# Corporate Report

**SUBJECT:** Development Permit Application No. 7905-0329-00

**Proposed Industrial Buildings in South Cloverdale**

18515 – 53 Avenue & 5298 – 185A Street Follow-up to Two Delegations to Council

Appendix I Revised Height Elevation for Building C

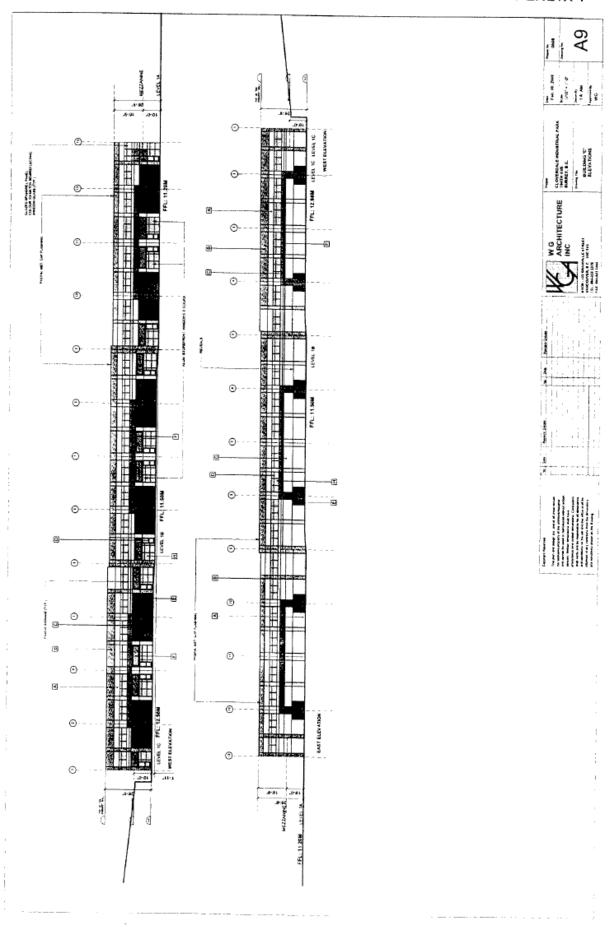
## 1. <u>Height of Building C</u>

The applicant has agreed to lower the height of proposed Building C by 3.25 metres (10.7 feet) from 11.4 metres (37.4 feet) as originally presented to Council, to 8.15 metres (26.7 feet). In addition, the applicant has agreed to register a Section 219 Restrictive Covenant to restrict the height of Building C or any other building built on the eastern portion of the site, to 8.15 metres (26.7 feet).

While Mr. McLennan requested that the height of Building C not exceed 5.5 metres (18 feet) and Dr. Verma requested a maximum of 6 metres (20 feet), the applicant has indicated that the height of the building is critical to its use. The applicant has indicated that most tenants and prospective purchasers of warehouse buildings require a clear height under the trusses of at least 7.0 metres (23 feet) to allow for use of racking for the storage of goods and materials. Based on these criteria, the developer has proposed a revised building height of 8.15 metres (26.7 feet) to allow for clear height under the trusses, plus depth for the roof structure. Based on this revised building height of 8.15 metres (26.7 feet), there is no potential for mezzanine space on the eastern side of Building C.

The change to Building C is reflected in the attached drawing number A-9 of Appendix I. The two other proposed industrial buildings will remain at a maximum height of 11.4 metres (37 feet).

SECTION ALONG EAST PROPERTY LINE SCALE I REP GO

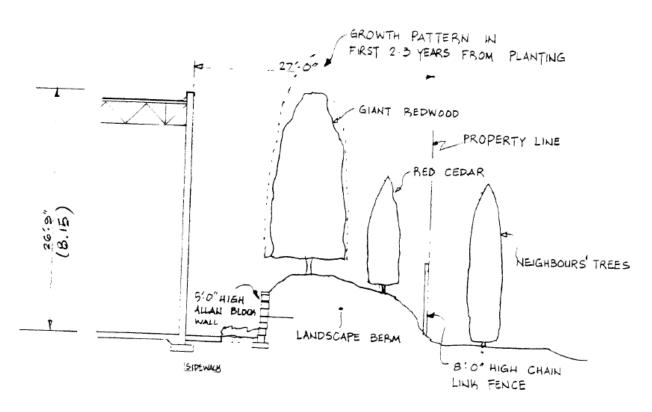
## 2. Retaining Wall

As requested by the neighbours, the developer has agreed to continue the retaining wall along the entire eastern side of the property and to install a black-coated chain link fence in advance of building construction. These changes are reflected in attached schematic drawing (Appendix II).

Appendix III Revised Landscape Plans for East Property line Appendix IV Map of Subject Site and Surrounding Area

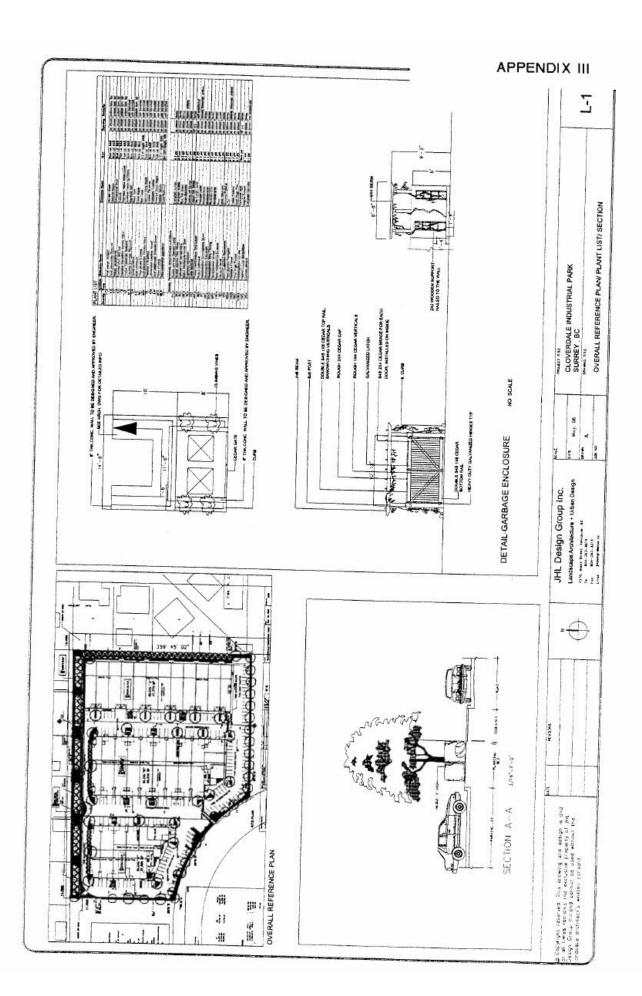
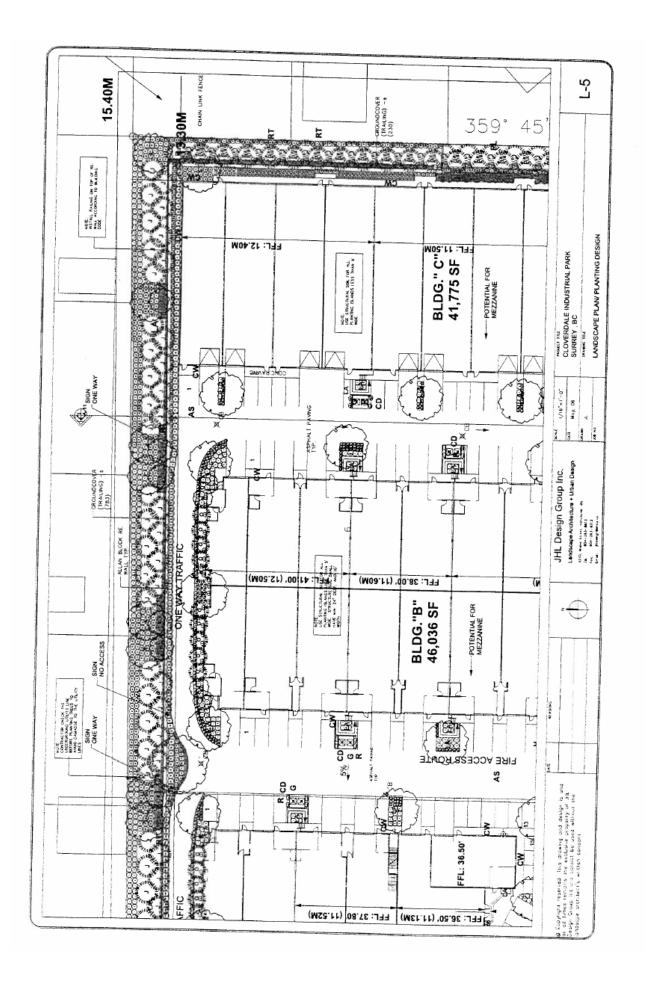
## 3. <u>Landscaping</u>

The residential properties to the east of the subject site (including Mr McLennan's and Dr. Verma's), were required to install a 6-metre (20 foot) wide landscaped buffer as a condition of subdivision approval. This buffer area is bermed and planted with a variety of flowering shrubs and coniferous and deciduous trees. Landscaping of the industrial site will include the 7-metre (23 foot) wide setback area along the east side of Building C. This 7-metre (23 foot) wide area, plus the existing 6.0-metre (20 foot) buffer area on the residential properties results, in 13 metres (43 feet) of landscaped buffering. In addition, the applicant has agreed to raise the berming and plant taller, more mature trees within the buffer area in order to further address the residential-industrial interface.

By continuing the retaining wall along the entire eastern side of the Building C, the landscaped bermed can be raised up to 2 metres (7 feet) in height. Within the raised berm, the developer has agreed to plant 26, 6-metre (20 foot) high Sequoia Trees, along with 99 Red Cedars, in a staggered pattern along the eastern property line. The total height of the proposed bermed landscape buffer would be 8 metres (27 feet) when planted.

Holly will be added as groundcover, as requested, in order to discourage access to the landscaped area, whereby increasing security. These changes to the landscaping are reflected in drawing numbers L-3 and L-5 of Appendix III.

DETAIL OF BUILDING C ~ EAST ELEVATION CORNICE CLOVERPALE IND. PARK JUNE 5,2006

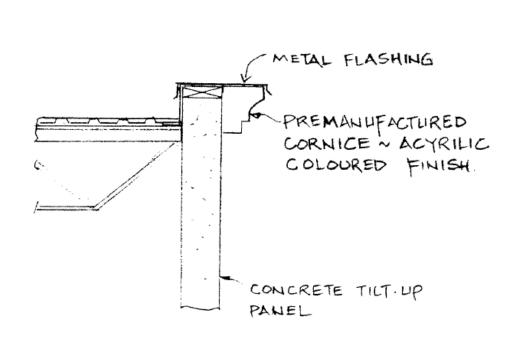
## 6. <u>Building Design</u>

Since the top 0.15 metre (0.50 feet) of the rear side of Building C will initially extend above the proposed landscaping on the east side, and no exposure to the north side, the developer has agreed to design and install detailing, such as a cornice, along the roof-line in order for the design to be sympathetic to the adjacent homes (Appendix VI).
